8XC196KB SPECIFICATION UPDATE

Release Date: December, 1996

Order Number: 272835-002

The 8XC196KB may contain design defects or errors known as errata. Characterized errata that may cause the 8XC196KB's behavior to deviate from published specifications are documented in this specification update.

001. I_{TL} Specification Change From -650 μA to -800 μA

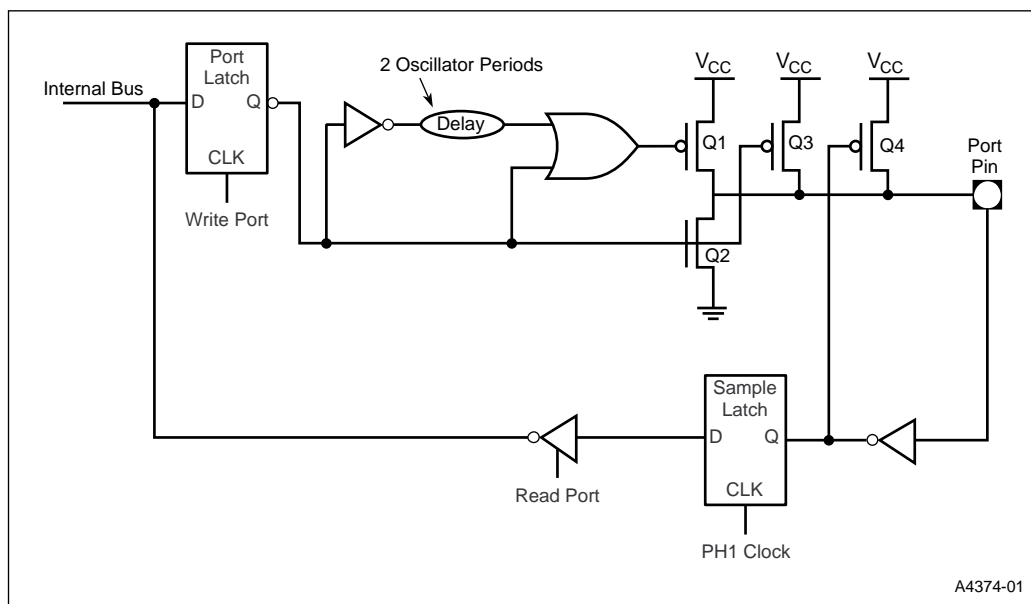
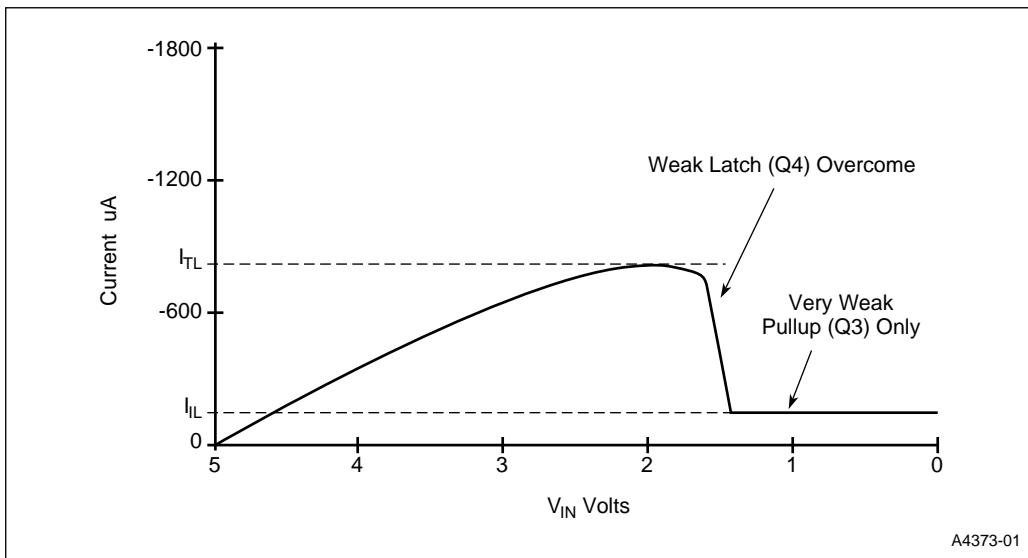
PROBLEM: To meet the device characteristics at low temperatures, the specification for I_{TL} on the 8XC198 and 8XC196KB/8XC196KB16 (where X = 0, 3, or 7) devices has changed from -650 μA to -800 μA .

The I_{TL} specification is the maximum current that the 8XC196KB quasi-bidirectional pins can source during the transition from a logic 1 to a logic 0 input. Figure 1 shows the quasi-bidirectional port circuit. When the port is configured as an input, the output of the port latch is a '0'. Therefore, Q3 is weakly pulling the port pin high. When the external circuitry drives the pin high, Q4 also is turned on and holds the port pin signal high. As the external circuitry decreases the voltage below V_{CC} toward logic 0, Q4 begins to turn off. However, due to transistor characteristics, Q4 will source increasing amounts of current until the threshold voltage of the transistor is reached. Then Q4 will turn off, leaving only Q3 driving the port pin signal high.

Figure 2 shows the transfer characteristic of the port pin during the input's transition from logic 1 to logic 0. The I_{IL} specification shows the amount of current Q3 will source after Q4 turns off. The I_{TL} specification gives the maximum amount of current that Q4 will source during the input's transition from logic 1 to logic 0.

IMPLICATION: Customers using the quasi-bidirectional pins as input should analyze their applications to see if their external circuitry can handle 80 μ A of current from the quasi-bidirectional pins during the transition period explained above.

Figure 3. Improved System Reset Circuit

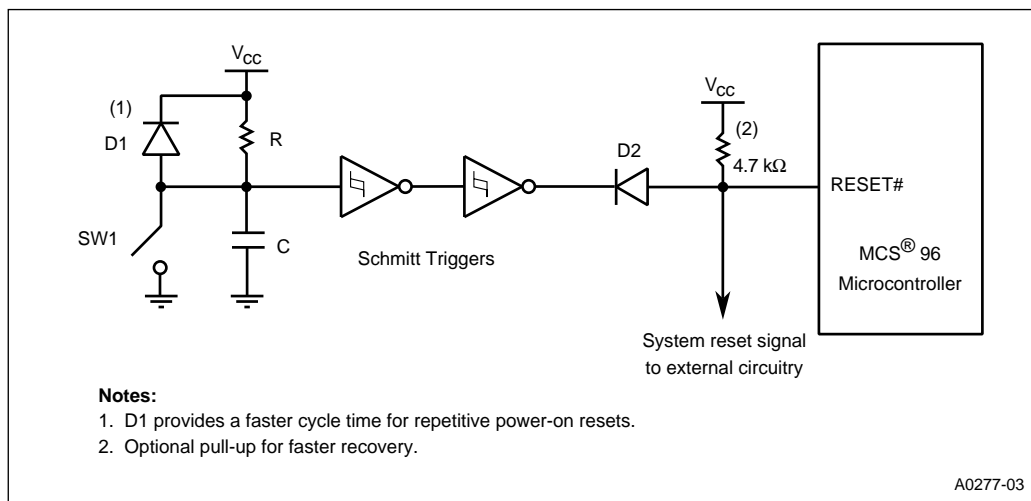
PROBLEM: The following improved system reset circuit shown in Figure 3 may be used in conjunction with the *80C196KB User's Guide (270651-003)*.

The system reset circuit in the *80C196KB User's Guide* has been used successfully by many customers for a long period of time. Both circuits should be evaluated in the user's system.

The main difference between the two circuits is the addition of a 4.7 KΩ pull-up resistor. In some systems, the internal pull-up resistor on the RESET# pin is not sufficient, resulting in a slow rise time. Therefore, the external pull-up resistor was added to allow a more predictable rise time on the RESET# input. The external pull-up resistor is optional, but it may help ensure a clean reset, either for the 8XC196KB or for the external system.

The improved system reset circuit will be included in the next revision of the *80C196KB User's Guide*.
